SERVICE NO. 1286A BULLETIN

LYCOMING SERVICE BULLETIN NO. 621B

DATE: October 5, 2015 Service Bulletin No. 621B
(Supersedes all versions of Service Bulletin No. 621A)
Engineering Aspects are
FAA Approved

SUBJECT: Diaphragm-Type Fuel Pump Replacement

Figure 1
Manufacturer's Code Location on
Fuel Pump P/Ns 62B26931 and LW-16335

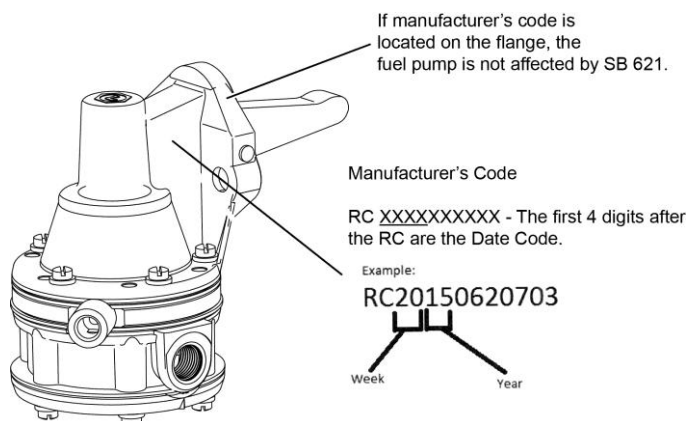
NOTICE: Each fuel pump has a 13-digit alphanumeric manufacturer's code, which begins with two
letters as shown in the example in Figure 1. The alphanumeric characters in the manufacturer's
code and its location on the fuel pump will help identify the fuel pumps affected by this Service
Bulletin. The first two characters in the example manufacturer's code RC20150620703 in
Figure 1 are **RC**. The next two numbers **20** identify the manufacturing week of the year as **20**
and **15** is the year. The manufacturer's code is on the fuel pump flange or on the web as shown
in Figure 1. If the manufacturer's code is on the flange as in the example in Figure 2, the fuel
pump is not affected by this Service Bulletin.

1. If the fuel pump is Lycoming part number 62B26931 or LW-16335 (ordered and sold as LW-16335-S but marked on fuel pump as LW-16335).
2. If the manufacturer's code is not on the flange but is on the web or other parts of the fuel pump.
3. If the fuel pump has **RC** (Figure 1) as the first two letters of the manufacturer's code.
4. If the manufacturer's code identifies the fuel pump as manufactured before, up to, and including the 25th week of 2015.

If any fuel pump meets **all** the criteria above, remove the fuel pump from the engine or from the spares inventory and:

- A. Review your records to identify shipping dates of the serial numbers of any of the affected fuel pumps.
- B. Return all affected fuel pumps to Lycoming Engines with a copy of this Service Bulletin and file a warranty claim per the warranty procedure herein.
- C. Record removal of the fuel pump installed on the engine in the engine logbook.
